Forest Edge

Stafford, Connecticut

REPORT

FOREST EDGE CONDOMINIUMS

SITE PLAN

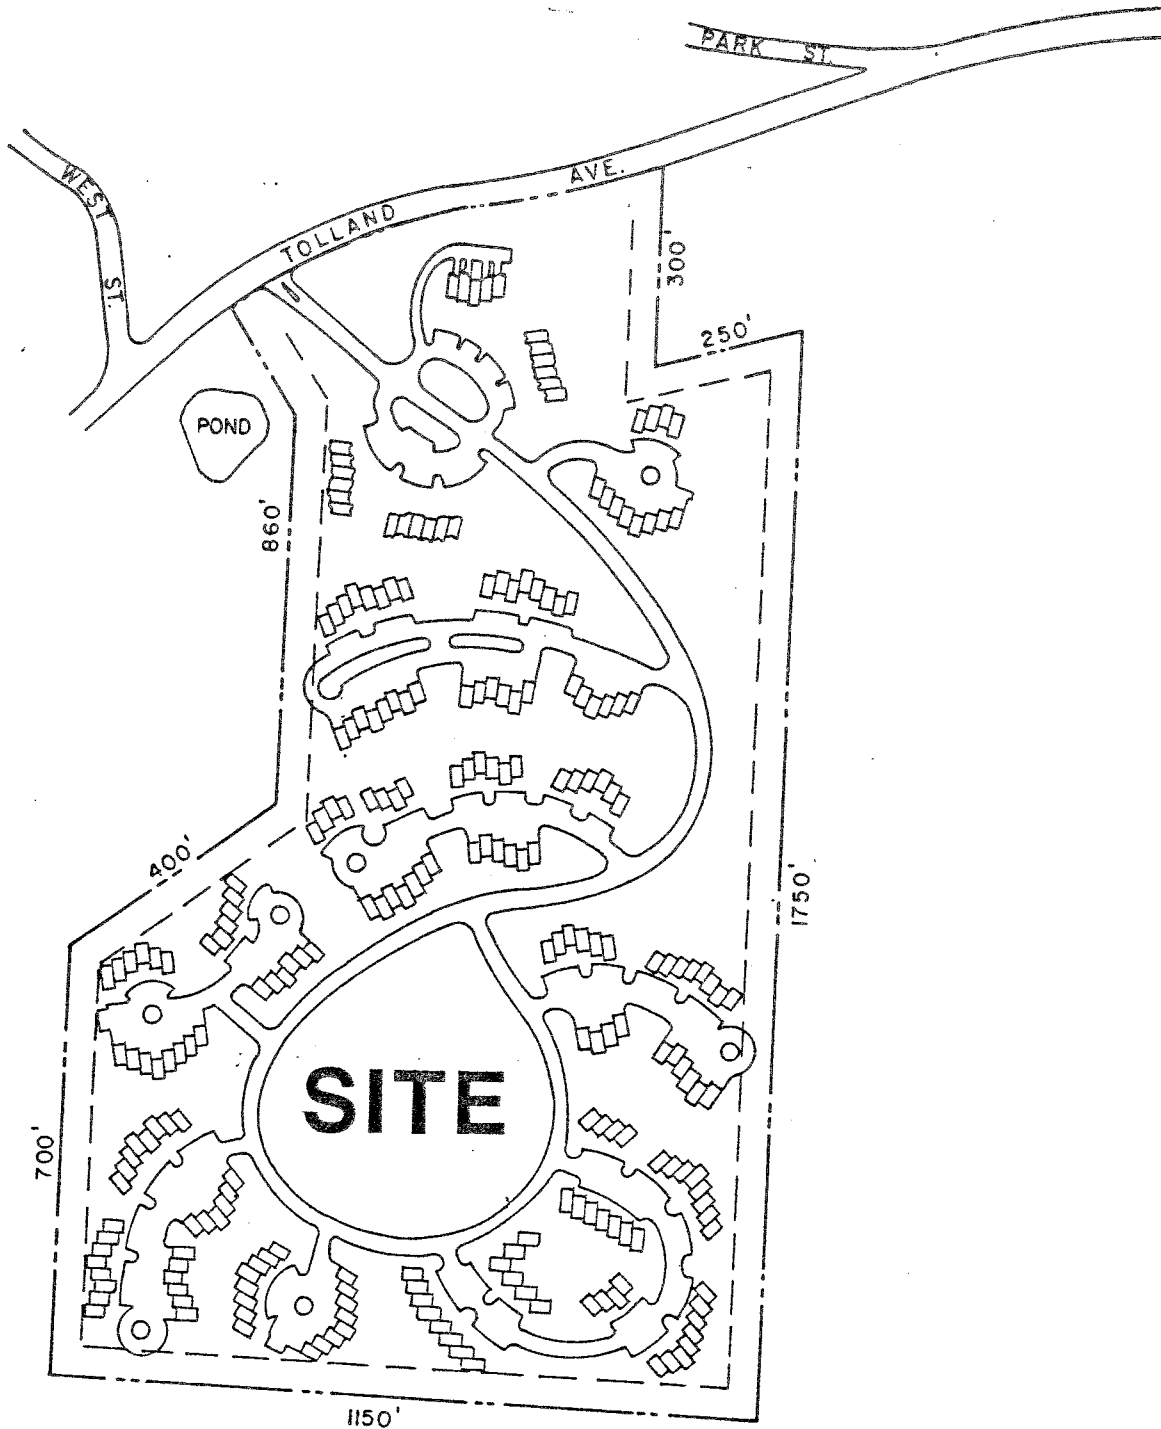
The plans as submitted were not comprehensive. They did not include pre- and post-development runoff computations and provisions for erosion and sediment control. Because of the moderate to steep slopes in the northern parts of the site, the erosion and sediment control plan should be of great concern. Also, the presence of moderately steep road grades in the northern parts will undoubtedly require that roads be sanded heavily during winter months. As a result, there is a good chance that road sand will accumulate in the catch basin on the site. Provisions will need to be made to remove the sand and debris on a regular basis. Also, streets should be swept in early spring.

The proposed road system seems to follow ridges quite well, which eliminates the need for some culverts. However, based on visual inspection of the site, it appears that the road may need to cross minor drainage channel(s). Detailed plans of all culvert crossings should be included in the storm water management plan.

One point to be made is that there is only one exit and entrance planned for this entire development of 244 units. That will cause much traffic at the intersection of this project with Tolland Avenue. The optimum solution for this problem is another access and egress point. If this is not possible at this time, then the Borough's plans should suggest to the developer at what point in the boundary of their property there should be provisions for a future access and egress.

--drainage behind the completed buildings, on the north side, is obviously inadequate as there has been some serious erosion already, a better drainage plan is needed
